Safety Notice

130011

Models Affected: GS-2669 DC
GS-3369 DC
GS-4069 DC

Subject: Machine Unladen Weight

Illustration 1

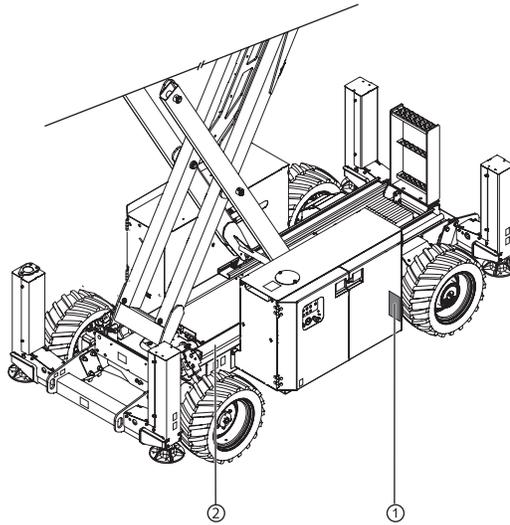
- 1 Locate all affected machines referenced on page 1 in your fleet. Refer to illustration 1 below for the serial label and serial number locations on your machine.

Note: The serial number printed on the serial label should be the same serial number stamped on the chassis of your machine.

- 3 Upon receipt of the new serial label, replace the one currently attached to your machine.
